APPLICATION FOR AN AMENDMENT OF A CONDITION OF AN EXISTING APPROVAL IN TERMS OF SECTION 15(2)(h) OF THE STELLENBOSCH MUNICIPAL LAND USE PLANNING BYLAW, 2023: ERF 181, DEVONBOSCH ESTATE, KOELENHOF

APPLICATION FOR PERMISSION REQUIRED IN TERMS OF CONDITION OF APPROVAL IN TERMS OF SECTION 15(2)(I) OF THE STELLENBOSCH MUNICIPAL LAND USE PLANNING BYLAW, 2023: ERF 181, DEVONBOSCH ESTATE, KOELENHOF

COMMENT FROM THE DIRECTORATE: INFRASTRUCTURE SERVICES

TO	:	**The Director: Planning and Development**
FOR ATTENTION	:	**Bulelwa Mdoda**
FROM	:	**Manager: Development (Infrastructure Services)**
ENQUIRIES	:	**Tyrone King (Manager: Development)**
DATE	:	**15 July 2024**
RE.	:	**Farm 65/43: Amended SDP for Phase 2 (Block B)**
YOUR REF	:	**LU/16466**
OUR REF	:	**CIVIL 2665**

Drawing Title: SITE PLAN
Workstage: SDP. MUN. SUB.
Date: 2023-10-31 | Drawn: SK | Checked: AJ | Approved: AJ
Scale: As indicated
Drawing Number: 220066_AR_SDP-100
Revision:

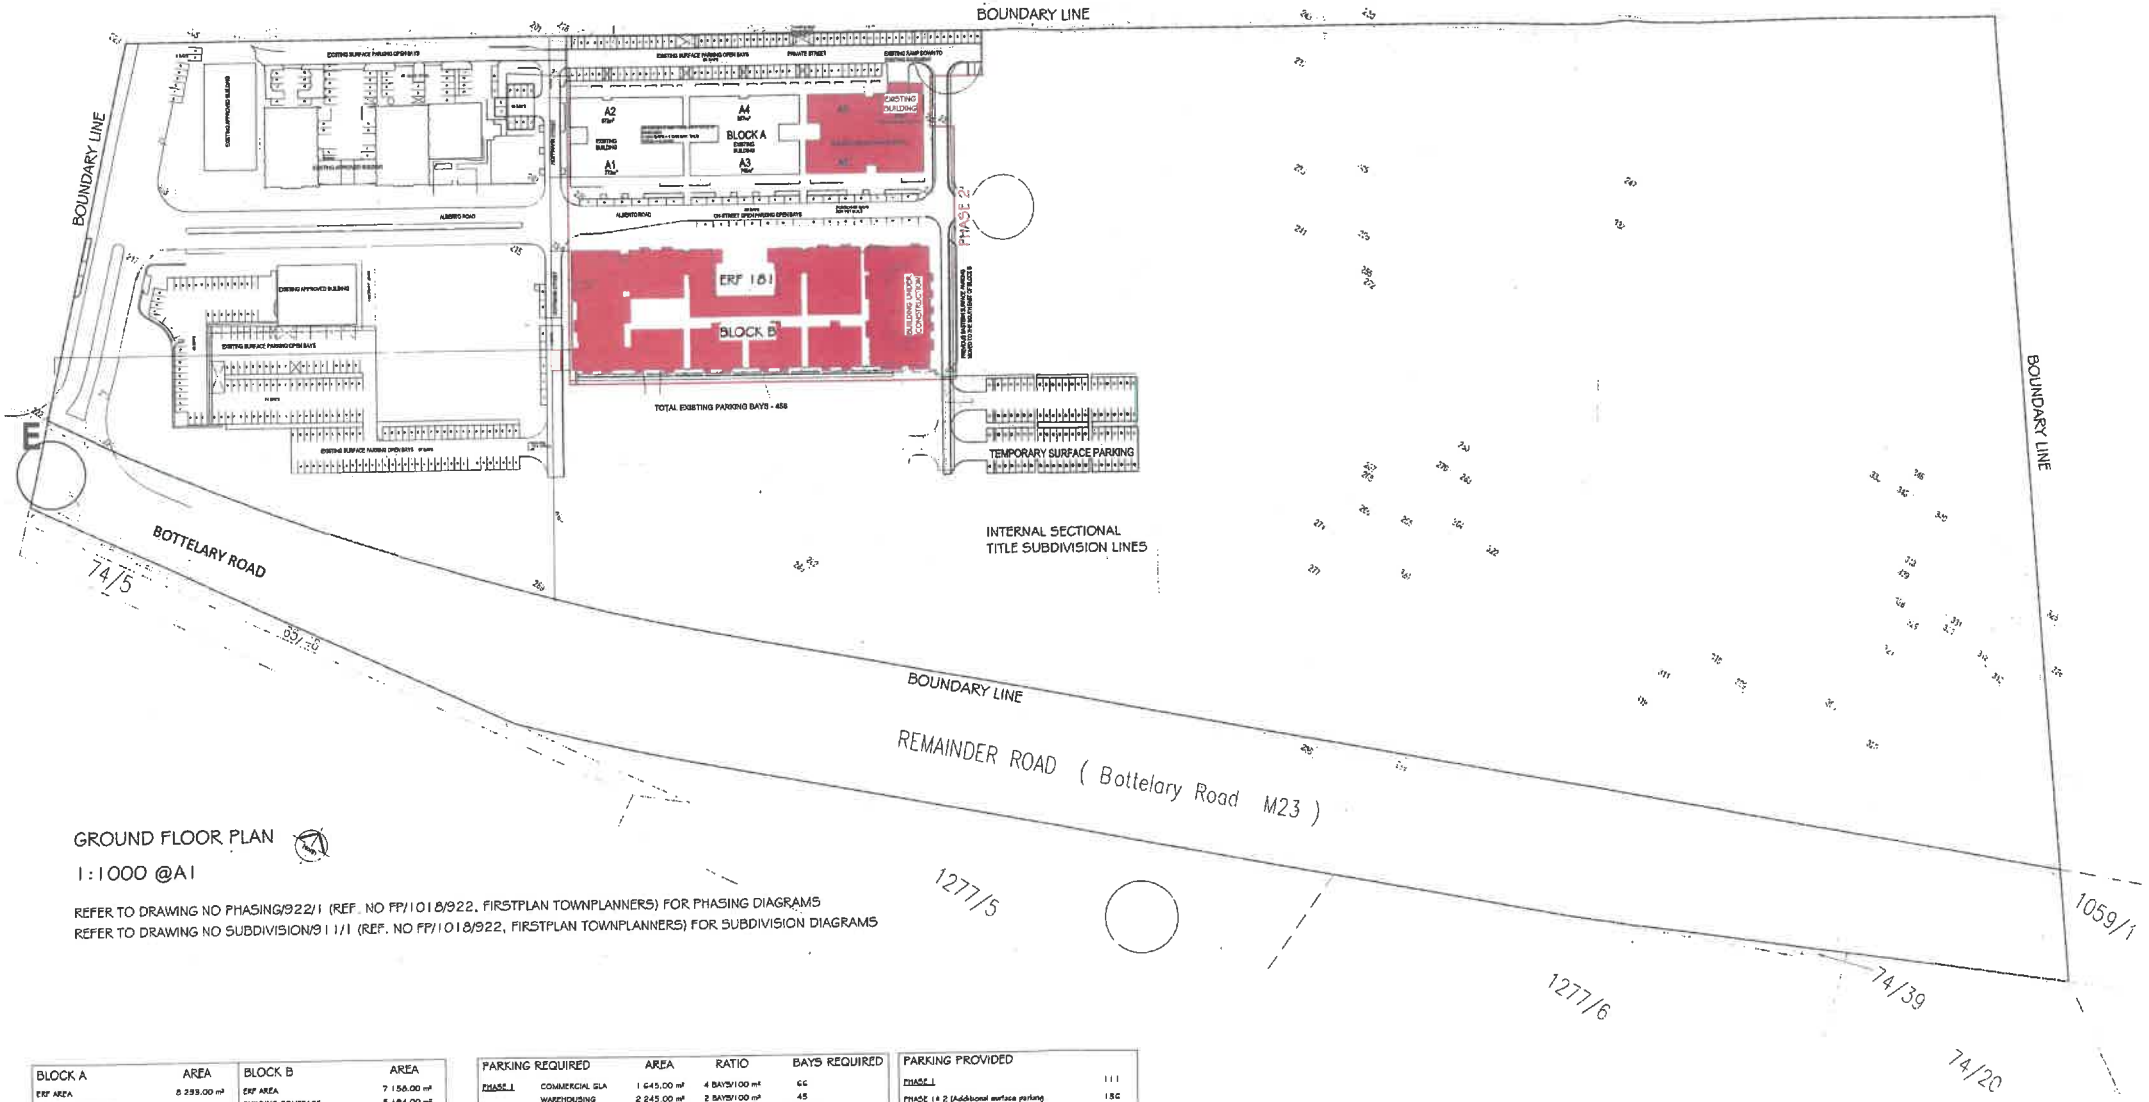
2.2.7 Sufficient on-site parking be provided in accordance with the provisions of the Zoning Scheme Bylaw as illustrated on the site development plan to the satisfaction of the Municipality.

- Site Plan 220066_AR_SDP-100 Rev 0, dated 2023-10-11 by Osmond Lange
- Devonbosch Development Bulk Register Phase 2 Water dated 17-May-2024 received from Bart Senekal Inc;
- Devonbosch Development Bulk Register Transport dated July 2024 Revision 5, by ITS;

The development is recommended for approval, subject to the conditions as stated below.

Figure 2 – SDP area on Phasing Plan

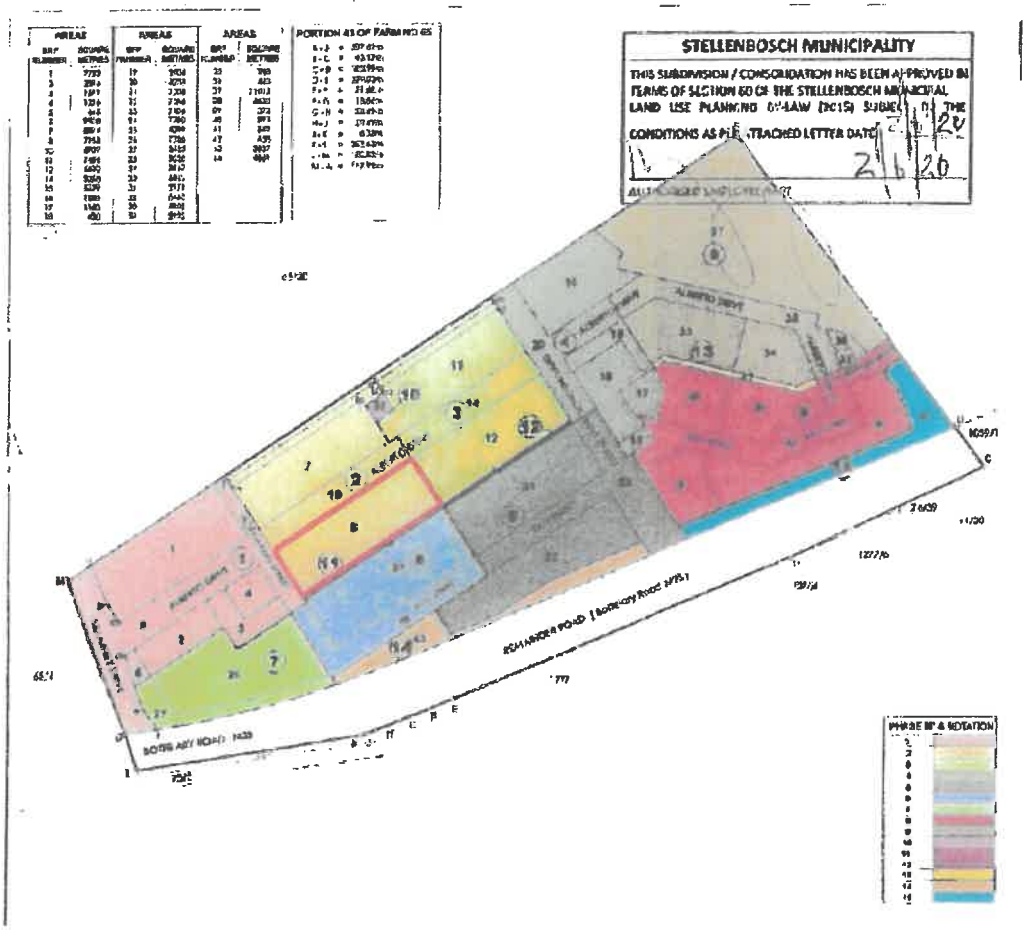
These comments, conditions as well as DC calculations are based on the above parameters and should it be exceeded, additional approval and revised DC calculations will become applicable.
